Application for Planning Permission. Town and Country Planning Act 1990

REVISION	DESCRIPTION	DATE	CHECKED BY
ASH DESIGN ASSOCIATES 141 LEMAN ST. LONDON E1 8EY			
PROJECT: PROPOSED REAR GROUND AND FIRST FLOOR EXTENSION			
CLIENT			
MR SAHOTA			
PROJECT ADDRESS			
NOS. 63/65 STATION RD UB3 4BG			
SCALE 1:200@A3	DATE 20TH DEC 2014	DRAWN BY OAA	ISSUE
STAGE -PLANNING		CHECKED BY OAA	
DRAWING No. EXI/BLK/200/02/ST63/14		PROJECT NO. 63STAT/EXT/DEC14	
DRAWING TITLE EXISTING BLOCK PLAN

Part two storey, part single storey rear extension and enlargement of roof space to create 2 x 2 bed self contained flats with amenity space and new retail area to rear. The scheme follows a refusal of planning application reference 18175/APP/2014/232.

REFUSAL OF PLANNING PERMISSION

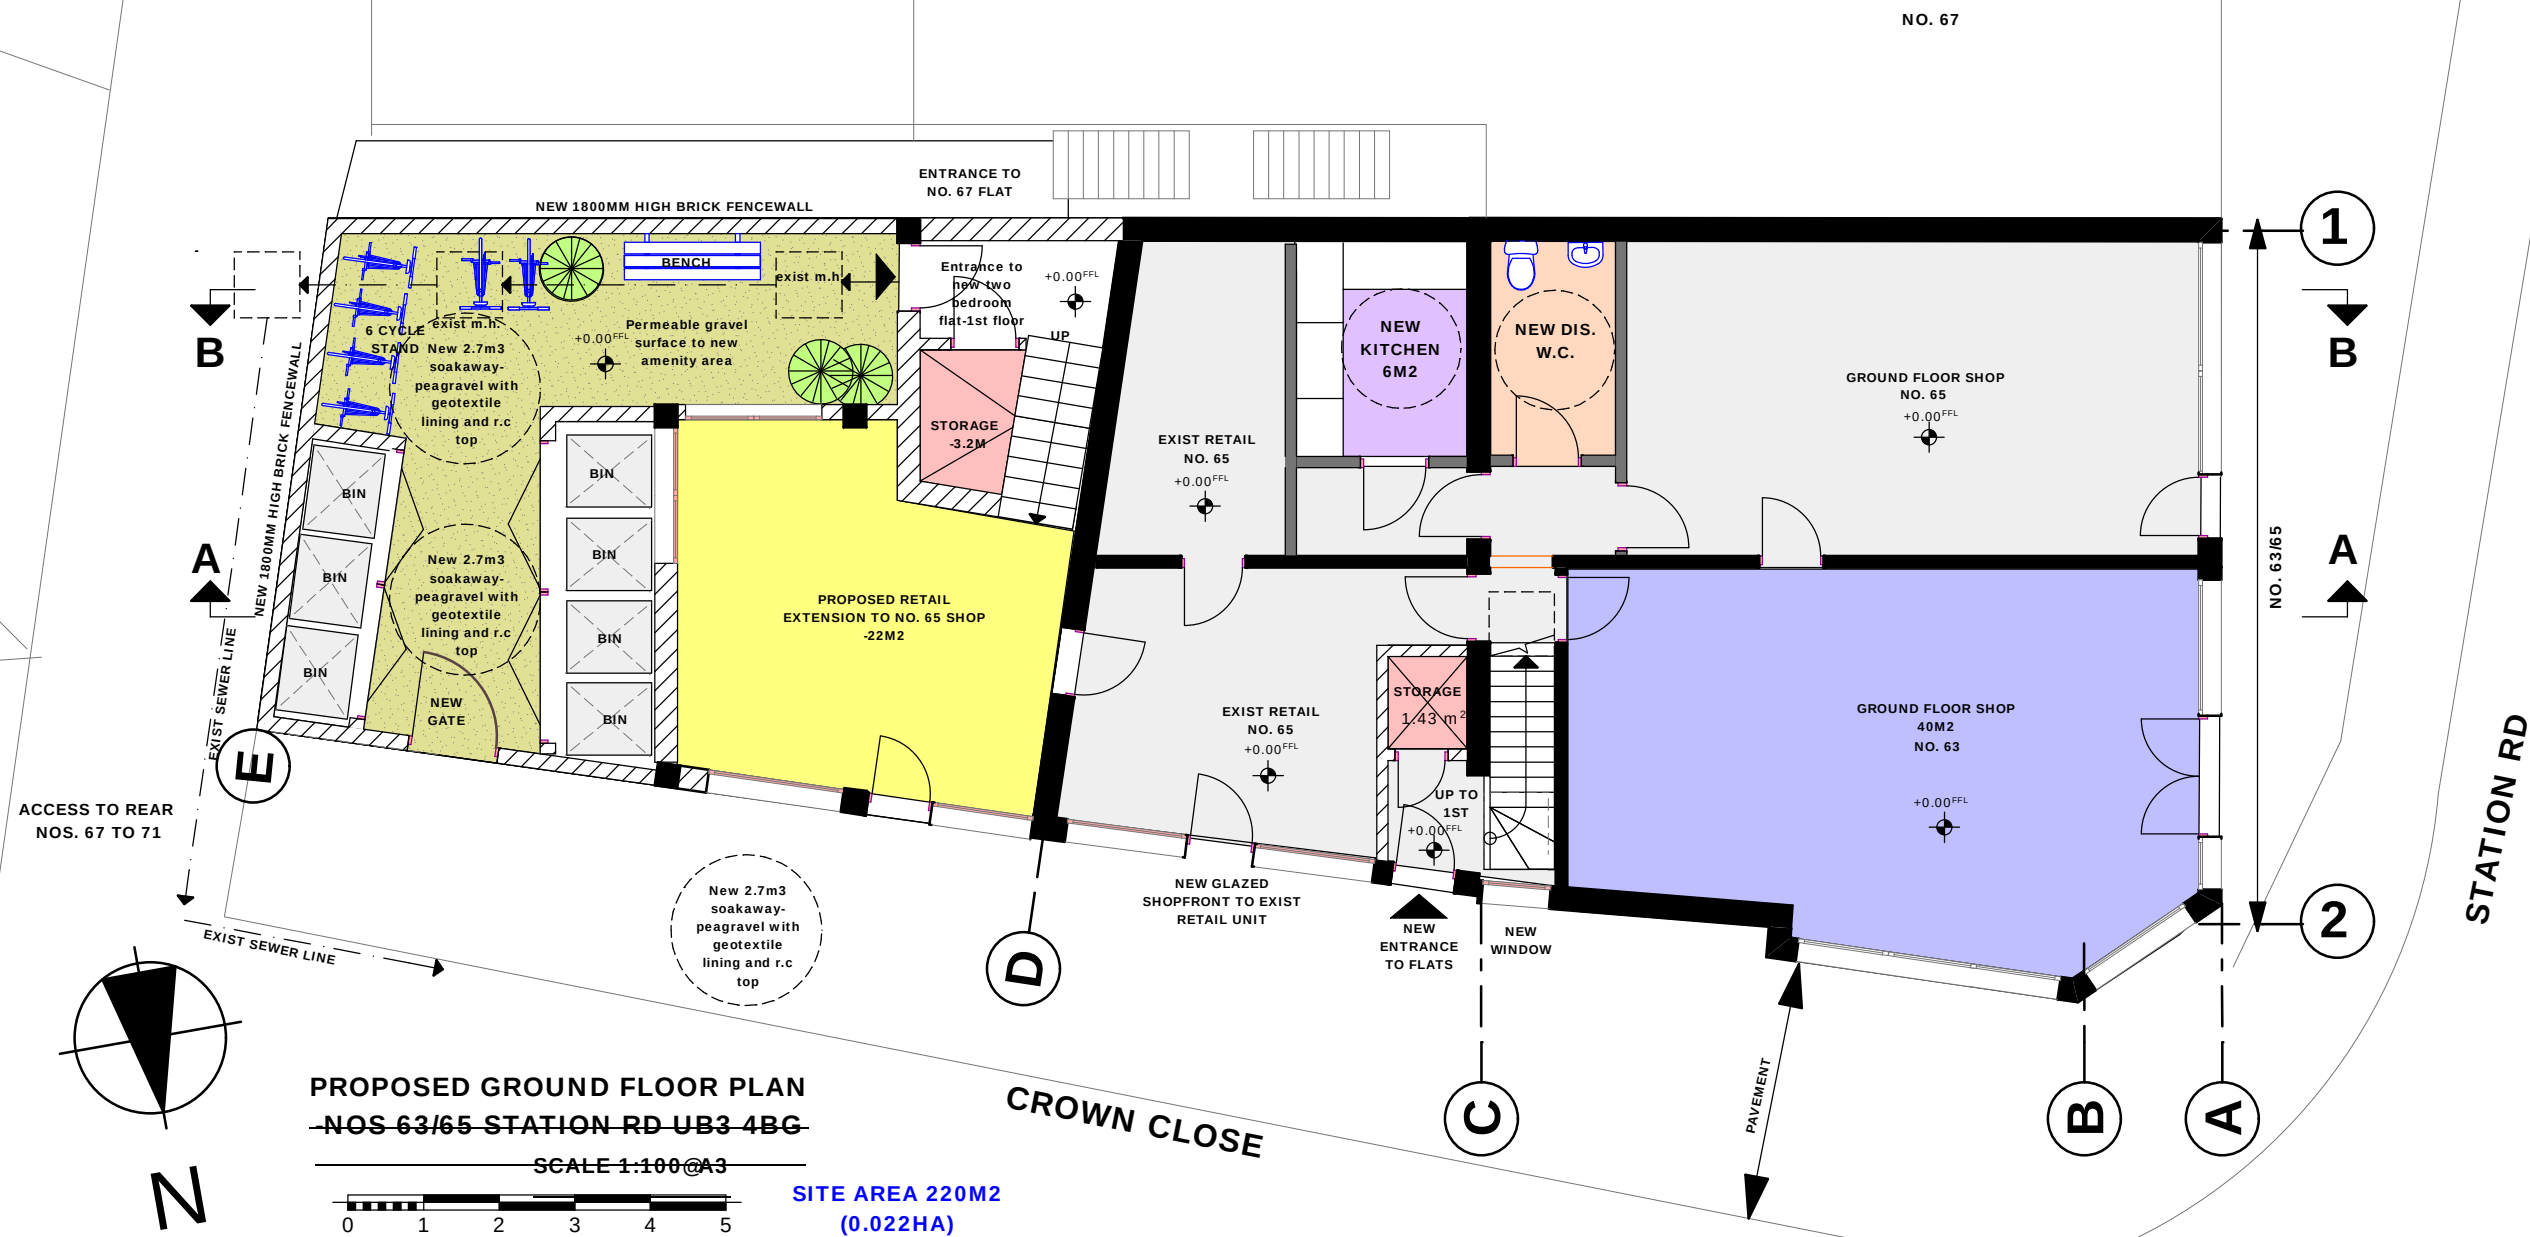
- No trees or other landscape features of merit will be affected by the proposal.
- Drawing No. PRO/GND/100/03/ST63/14 indicates a gated yard to the rear which will be accessible from Crown Close. This area will be dominated by bin and bike storage facilities with a token area of amenity space, sufficient to accommodate a bench seat and a couple of plants (in containers?)
- Other drawings indicate a small roof garden/patio at first floor level.
- If the application is recommended for approval, landscape conditions should be imposed to ensure that the proposals preserve and enhance the character and local distinctiveness of the surrounding natural and built environment.
